DISTRIBUTOR BULLETIN

2016 ENCLOSED UPDATES

2016 OPEN SNOW UPDATES

DOS Shield 09576

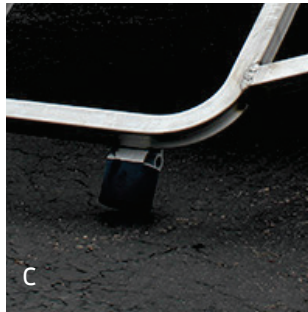
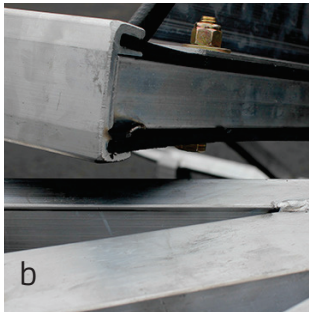
Tongue lengths on all tandem open snow trailers have been consolidated to 60" in length from the front cross member to end. With that change in mind, the DOS ramp was updated and tested. The DOS ramp can still be folded down for unloading without requiring you to turn or angle your trailer. This is displayed in image a. Image b demonstrates the increased gap between the tongue and unfolded ramp. Lastly the bumper placement has been moved to slightly lift ramp height and give better footing.
